**SITE PLAN REVIEW SHEET
ENVIRONMENTAL VARIANCE REQUEST ONLY**

CASE: SP-2021-0015D

PROJECT NAME: Crossroads Logistics

PROPOSED DEVELOPMENT: Industrial manufacturing warehouses

Figure 7 -- Floodplain, CWQZ and CEFs

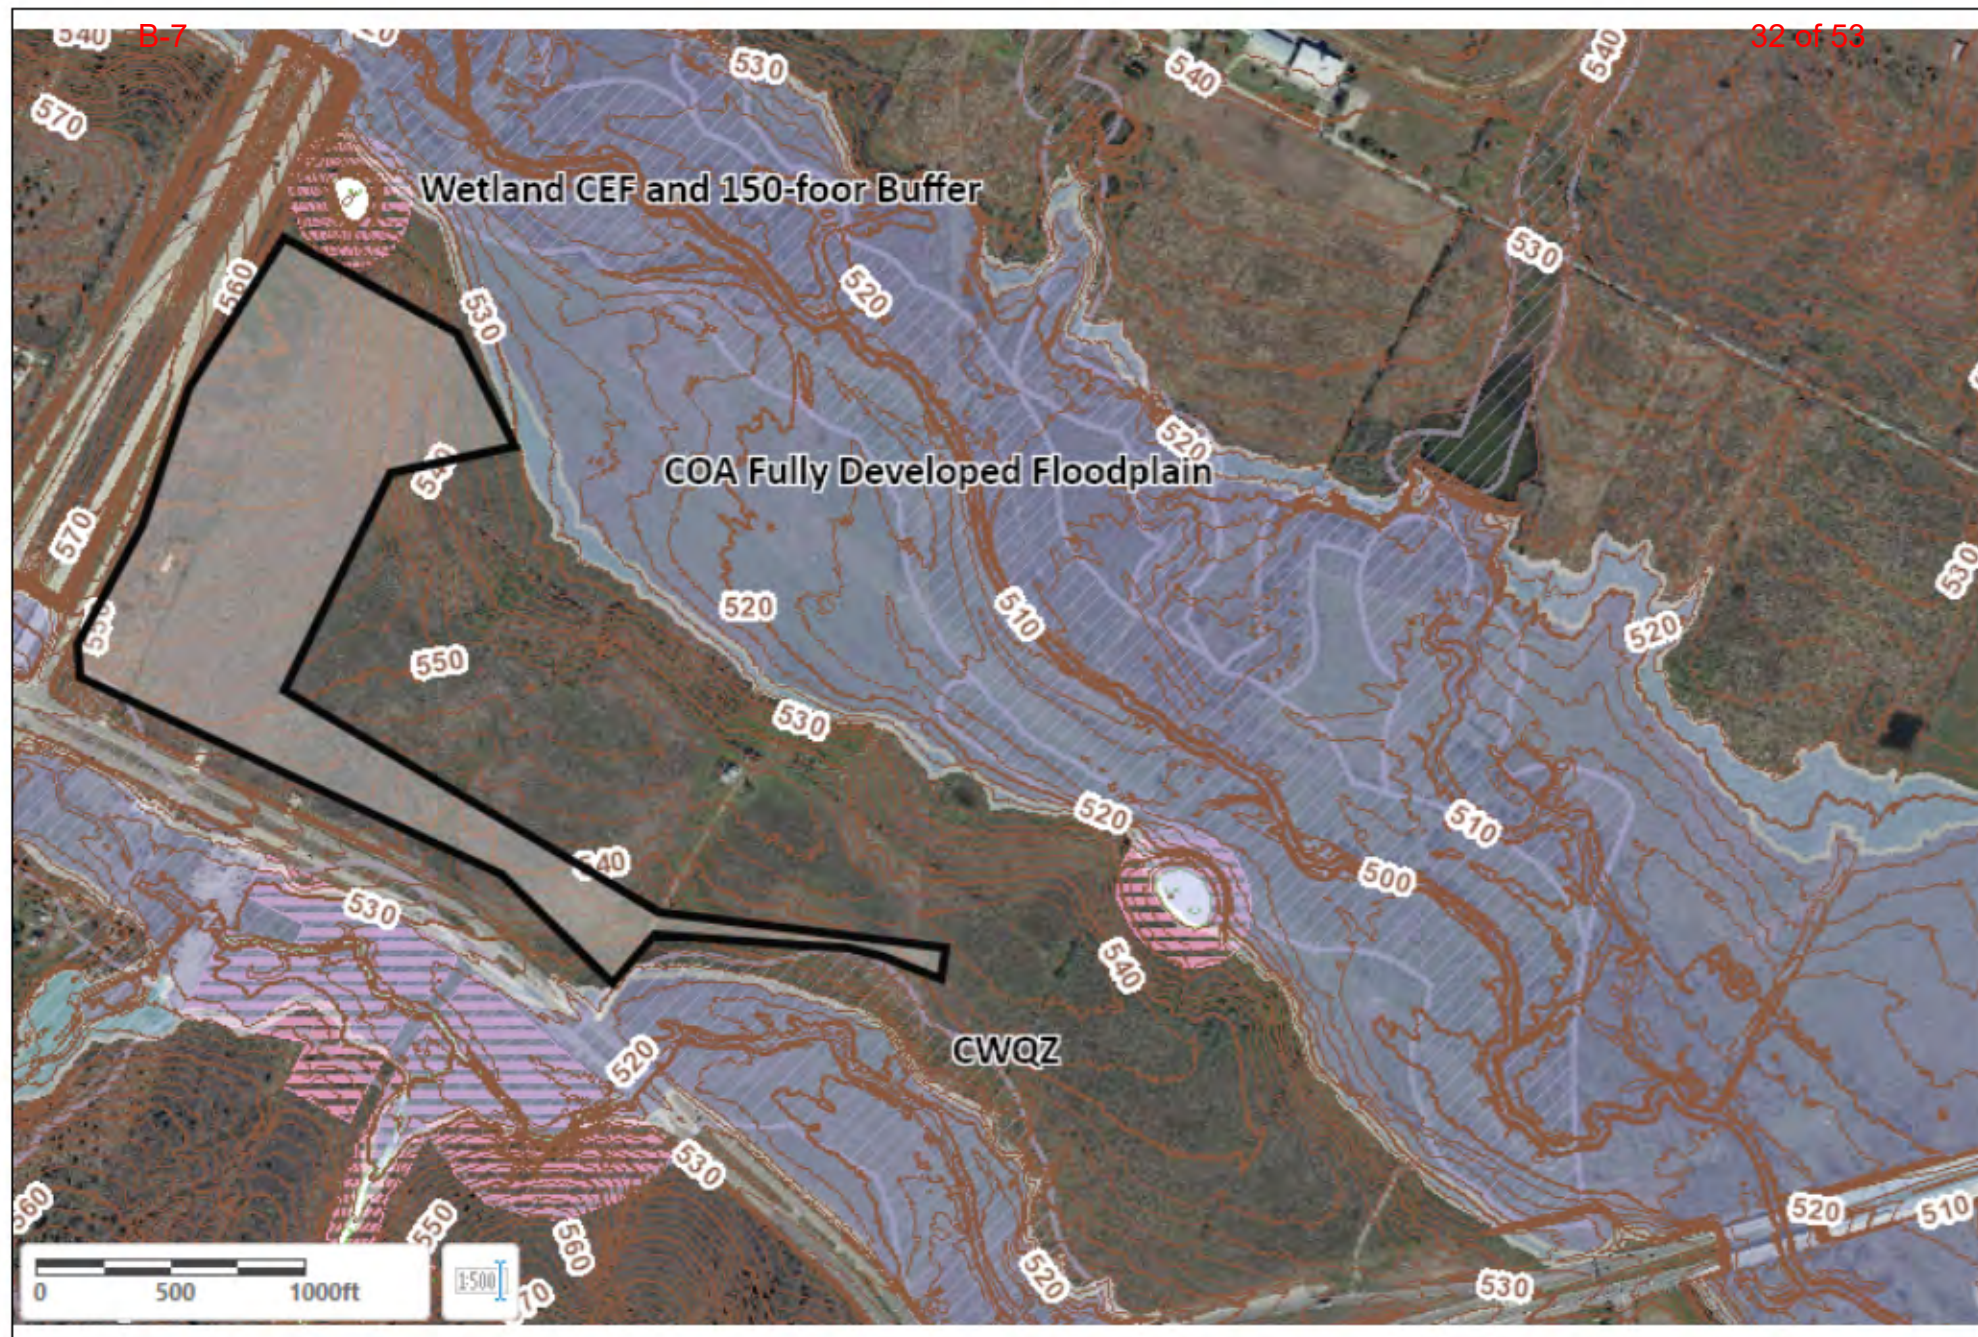
Moreover, the design decision provides greater overall environmental protection than is achievable without the variance. The project proposes to expand the wetland CEF setback from 150 feet to 200 feet and also plans to provide landscaping and tree replacement/mitigation in accordance with City zoning jurisdictional requirements—something not required within the City's Extra Territorial Jurisdiction.

- Provide a landscape plan in accordance with City zoning jurisdictional requirements.
- Provide tree replacement/mitigation plan in accordance with City zoning jurisdictional requirements.
- Increase the wetland CEF setback from 150 feet to 200 feet.
- Provide structural containment of the cut with retaining walls.

CROSSROADS LOGISTICS CENTER
CUT & FILL EXHIBIT
8400 E. PARMER LANE
AUSTIN, TEXAS 78653

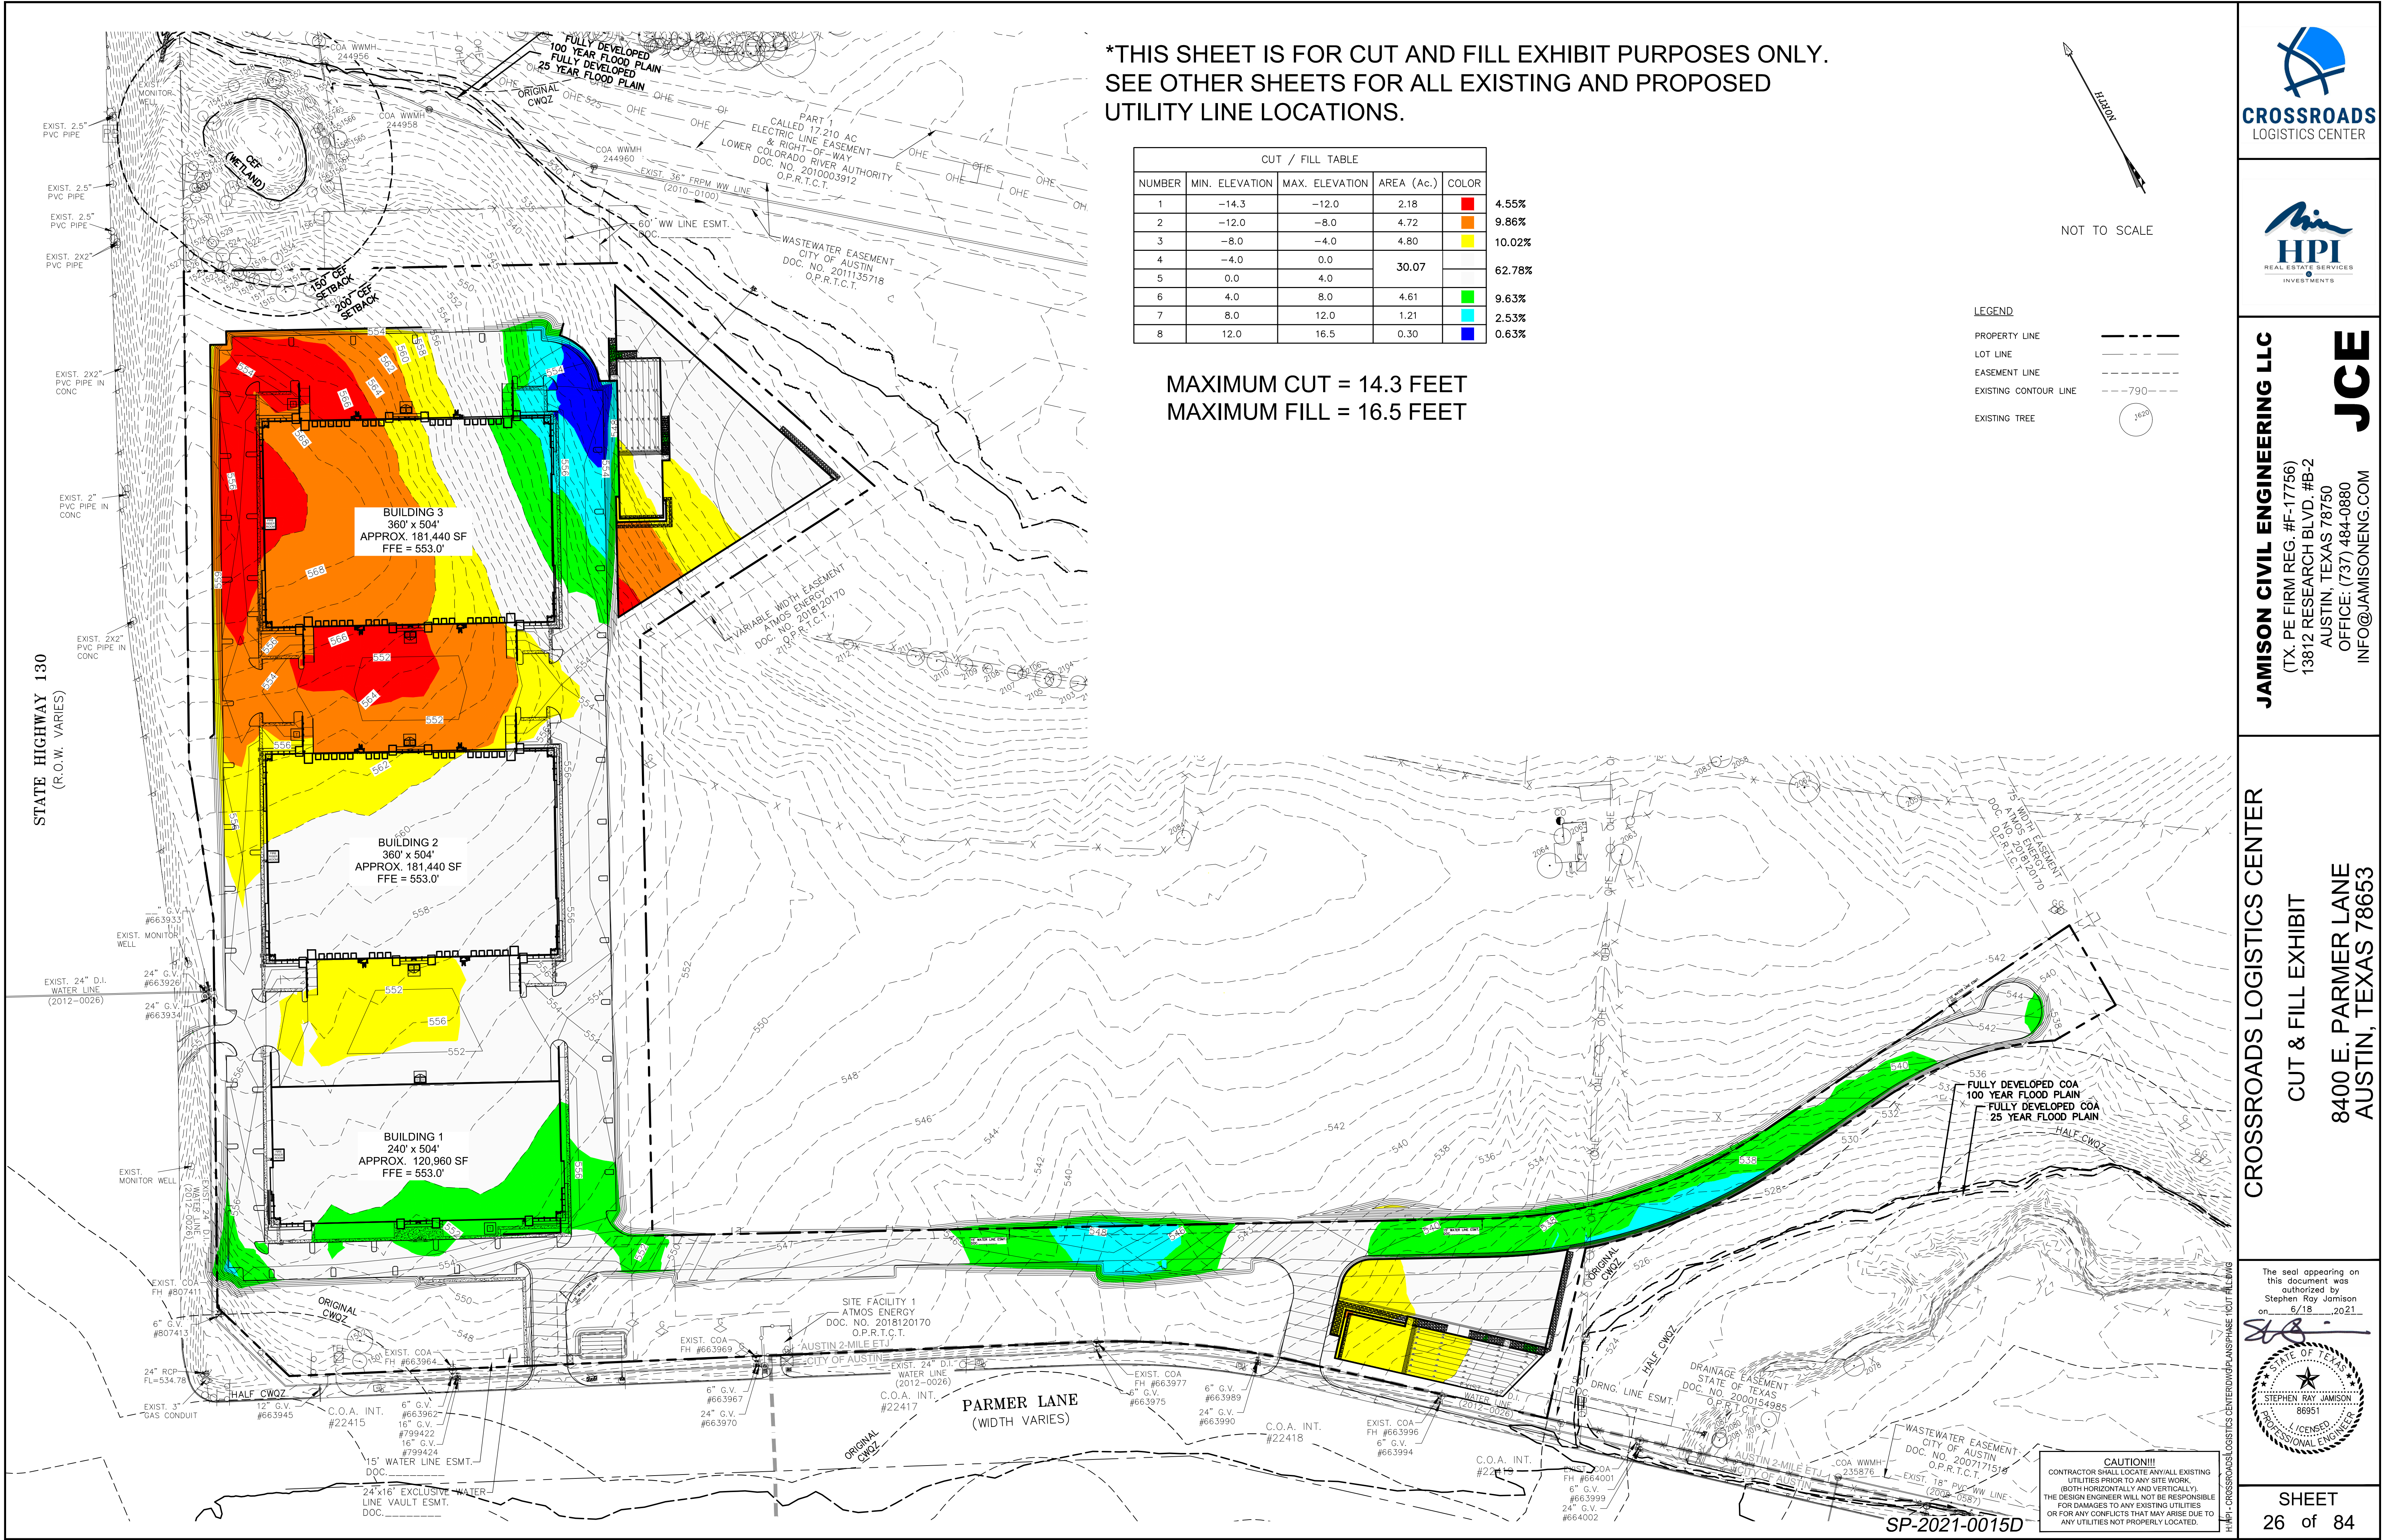
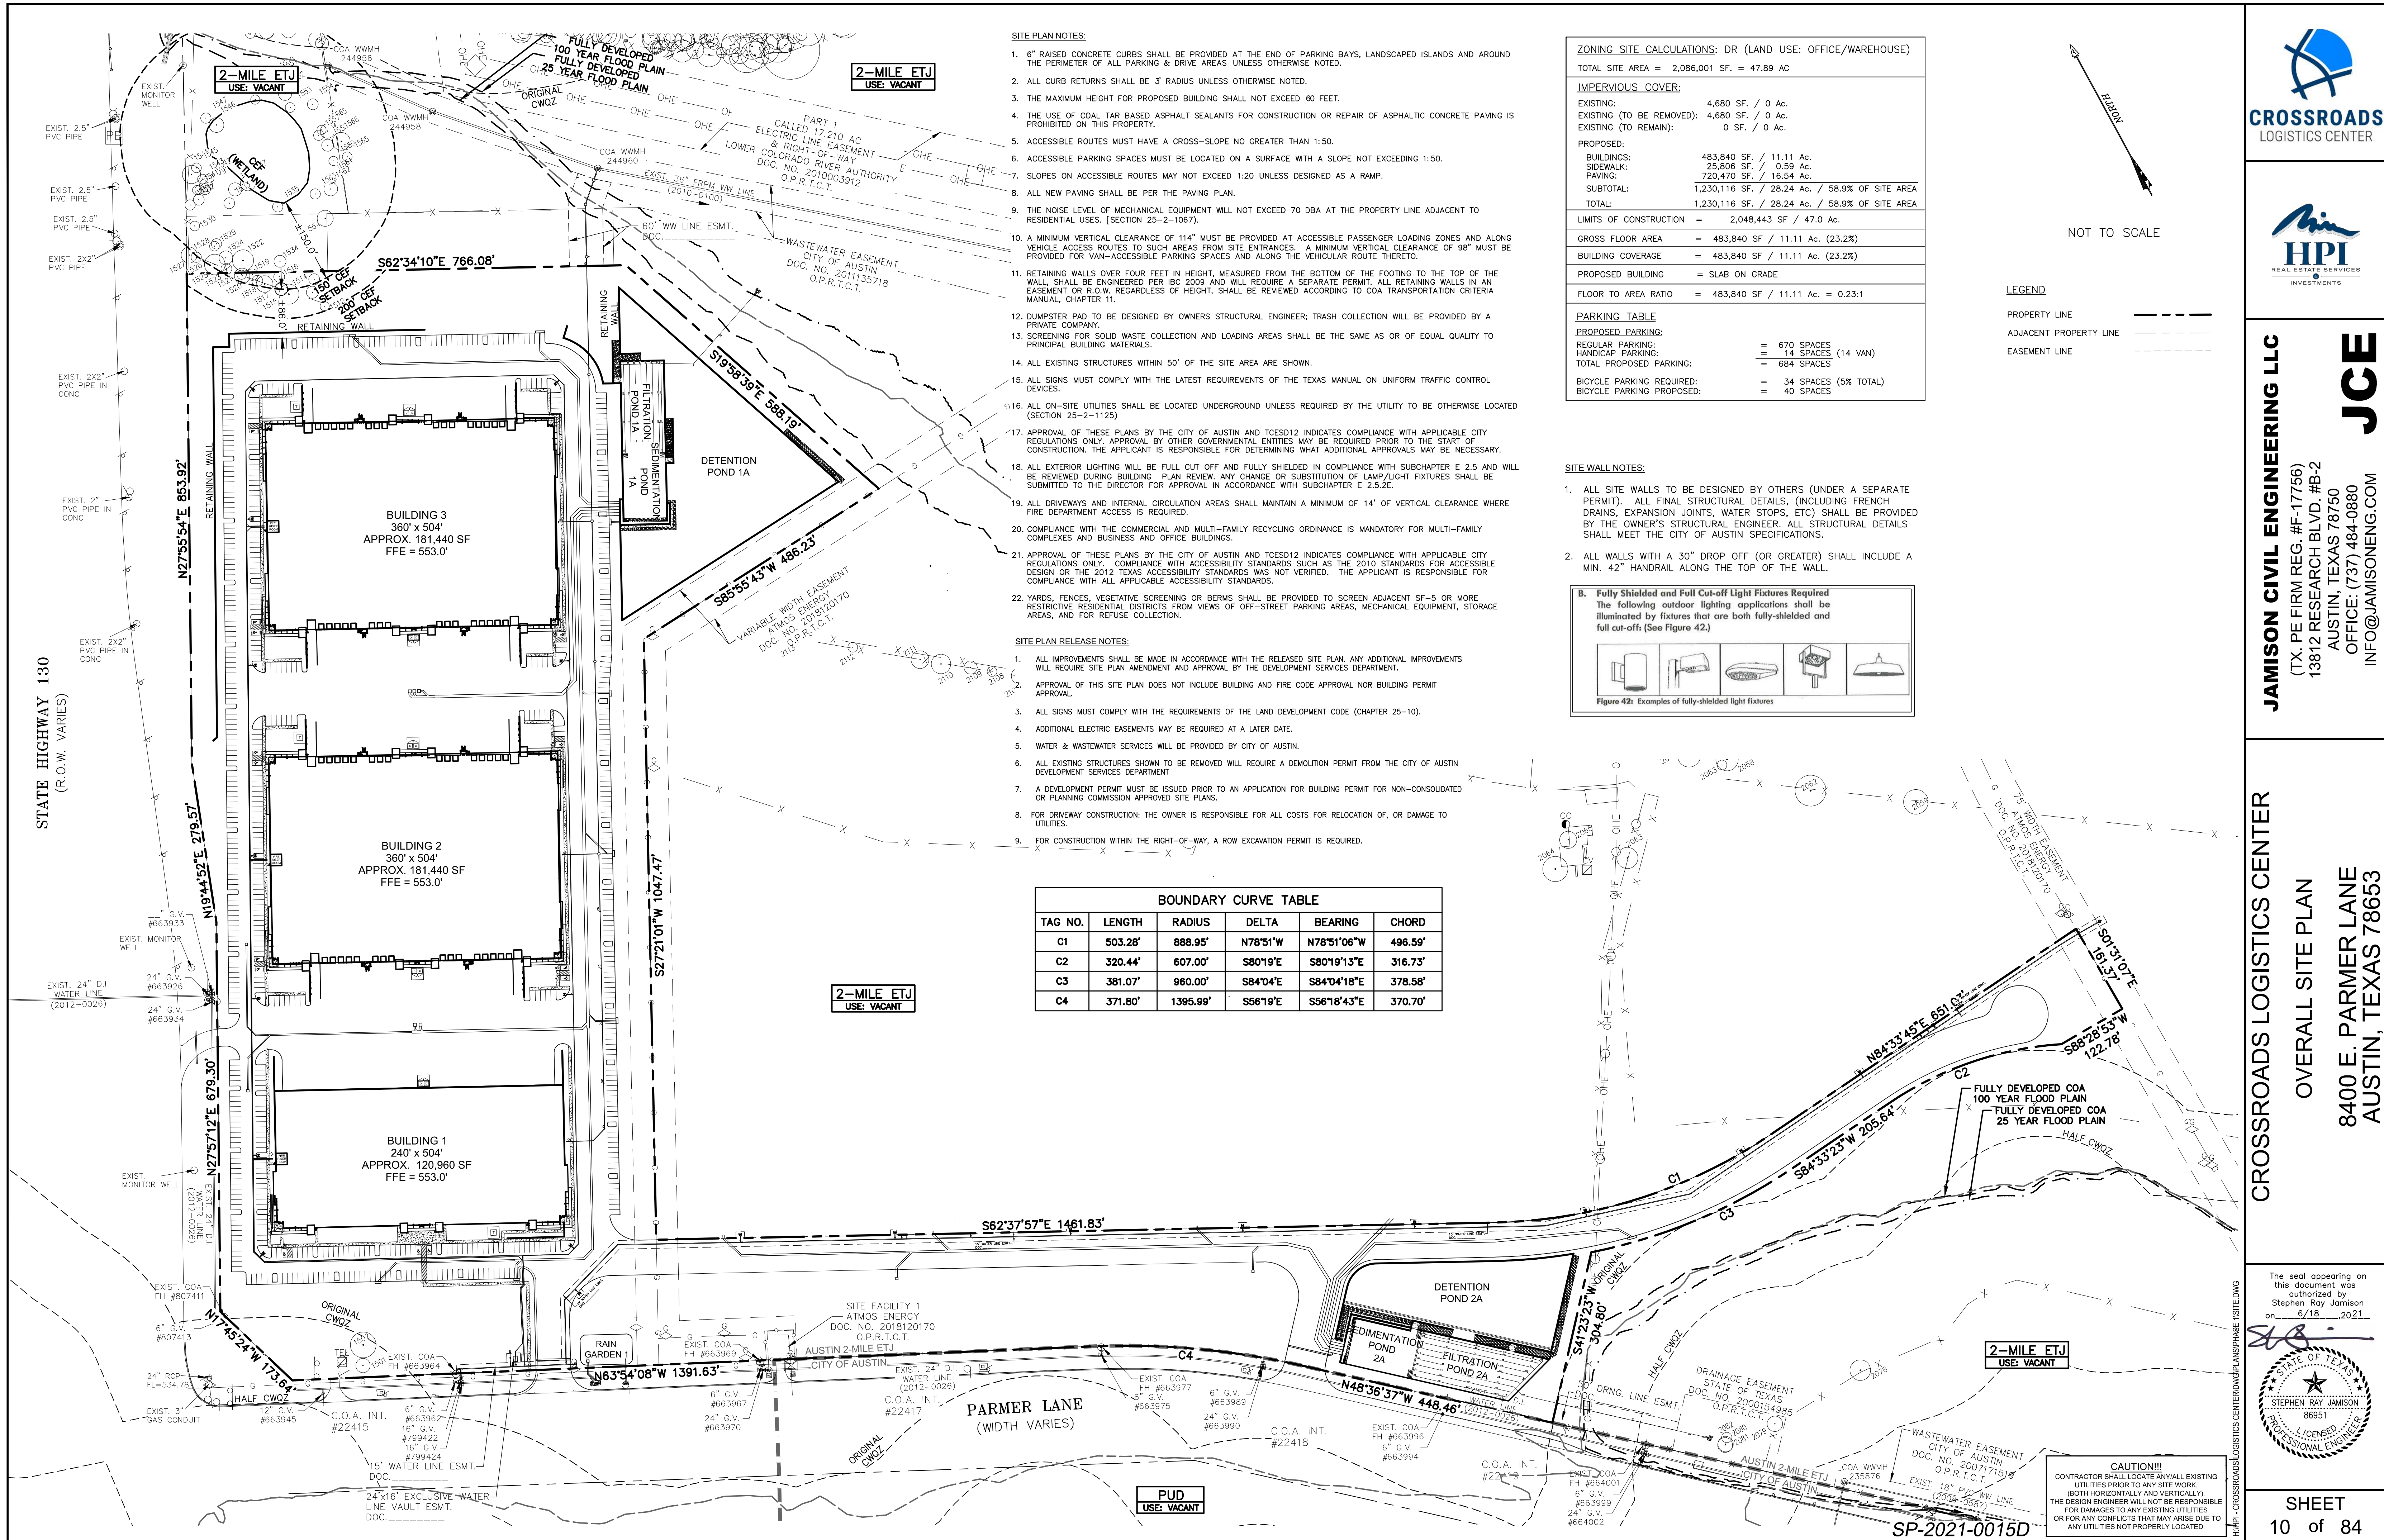
1. Request to vary from LDC 25-8-341 to allow cut up to 14.3 feet within the Desired Development Zone.
2. Request to vary from LDC 25-8-342 to allow fill up to 16.5 feet within the Desired Development Zone.

For the proposed project the situation is nearly identical. Due to the natural topography and the size of the buildings, 14.3 feet of cut is necessary to maintain level finish floor elevations, level truck courts, and truck lanes with grades less than 4%. Therefore, by not allowing this variance would deprive the applicant of a privilege available to owners of similarly situated property.

For the proposed project the situation is nearly identical. Due to the natural topography and the size of the buildings, 16.5 feet of fill is necessary to maintain level finish floor elevations, level truck courts, and truck lanes with grades less than 4%. Therefore, by not allowing this variance would deprive the applicant of a privilege available to owners of similarly situated property.

- Provide a landscape plan in accordance with City zoning jurisdictional requirements.
- Provide tree replacement/mitigation plan in accordance with City zoning jurisdictional requirements.
- Increase the wetland CEF setback from 150 feet to 200 feet.
- Provide structural containment of the fill with retaining walls.
